WYNNFIELD SUBDIVISION, UNIT THREE, **RESUBDIVISION OF LOTS 62 AND 63**

APPLICATION NUMBER 25 DATE June 5, 2003

WYNNFIELD SUBDIVISION, UNIT THREE, RESUBDIVISION OF LOTS 62 AND 63

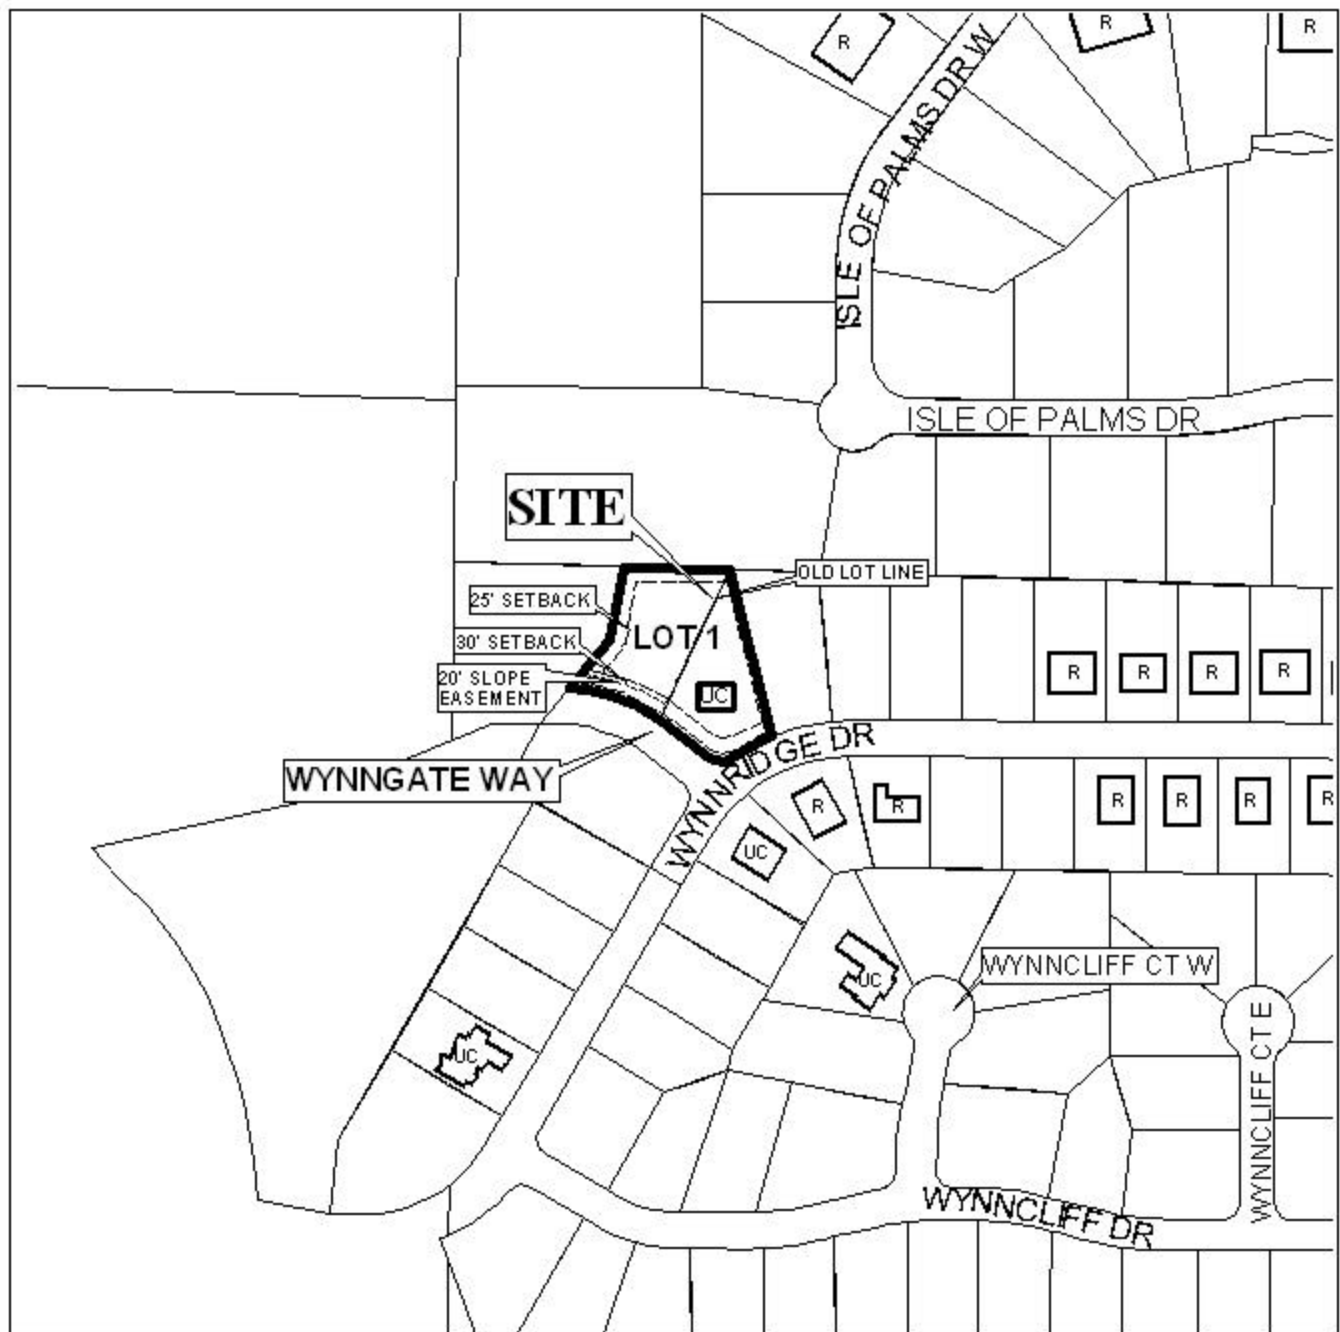
The plat illustrates the proposed 0.9 ± acres, 1 lot subdivision which is located on the Northwest corner of Wynngate Way and Wynnridge Drive. The subdivision is served by public water and sanitary sewer.

The plat meets the minimum requirements of the Subdivision Regulations and is recommended for Tentative Approval.
